# service bulletin

No. 91.6.007

AIRCRAFT SAAB SAFIR 91B, 91B-2 AND 91C

**SUBJECT:** Carbureter Marvel-Schebler MA 4-5.

Figure 1

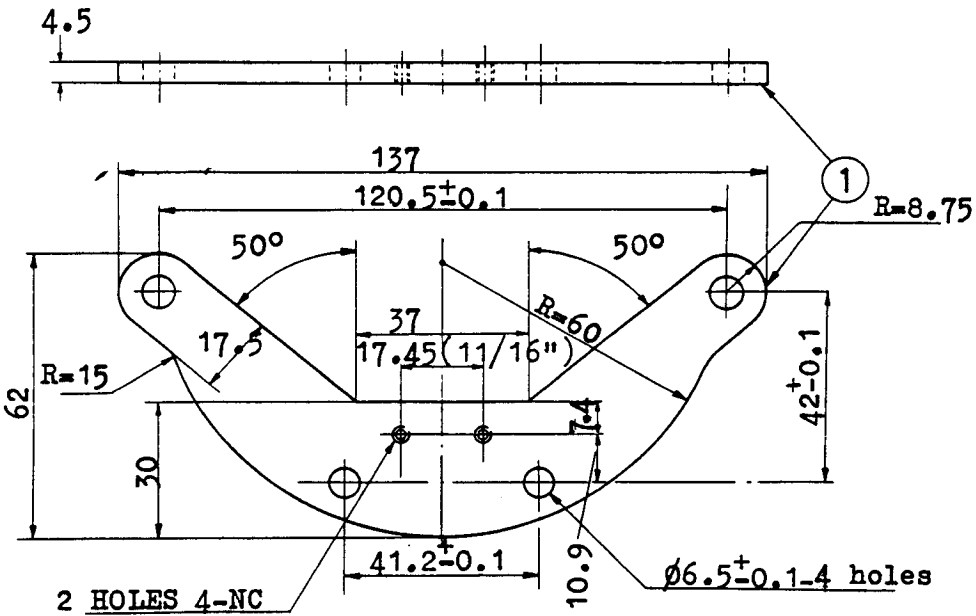
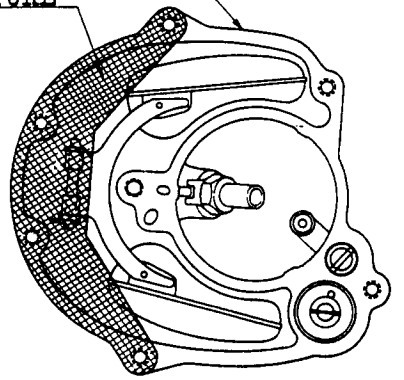
Assemble float and lever assembly to fixture according to fig. 1, using float lever shaft. Screw the fixture to fuel bowl using 4 screws according to fig. 2. By moving the floats up and down when holding the bowl in different positions any contact of floats with the walls of fuel bowl can be detected. If contact is detected, the float lever must be adjusted to obtain at least 1 mm clearance between floats and fuel bowl.

FIGURE 3

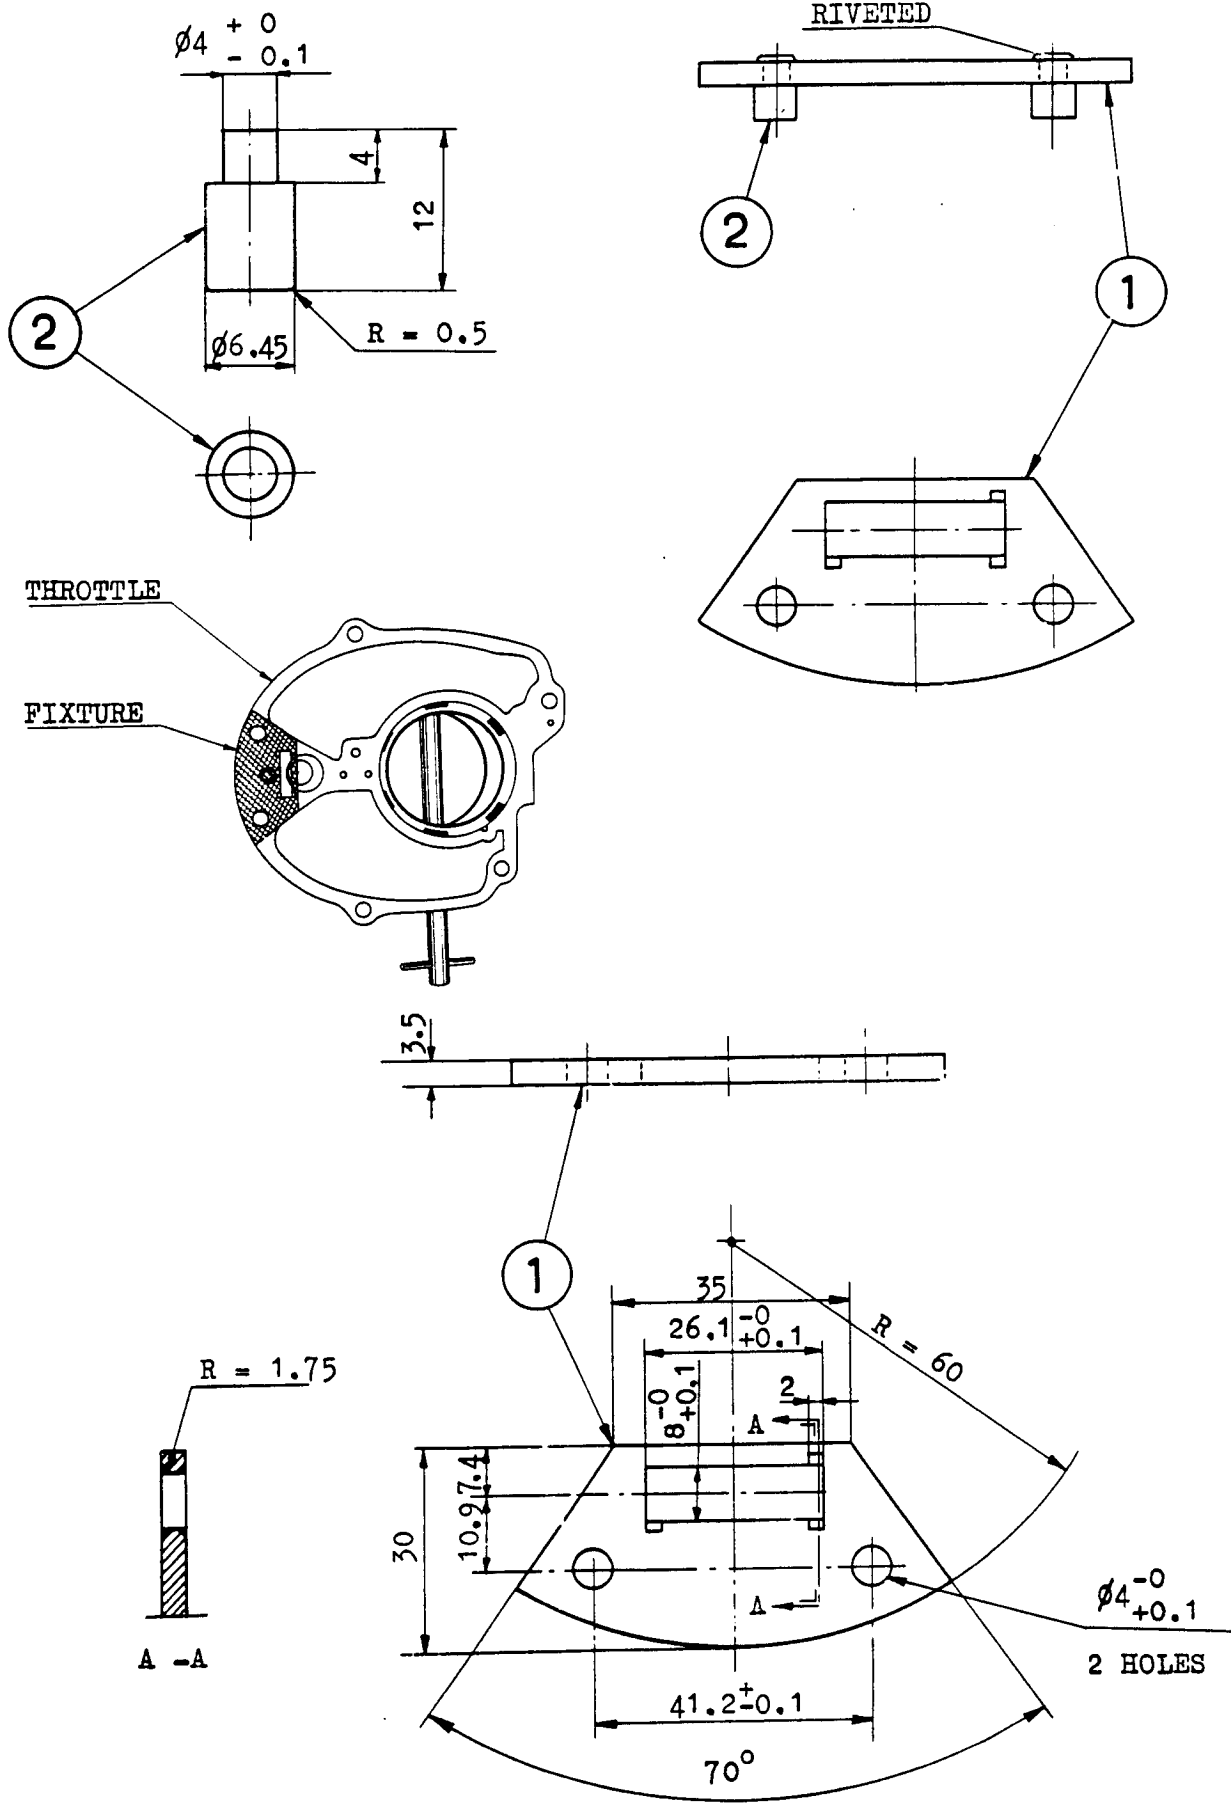
Check position of the float bracket in relation to throttle body with fixture according to fig. 3.

If adjustment is necessary remove solder on float bracket screws, loosen the screws and locate the bracket according to fixture.

Tighten the screws and secure them with solder.
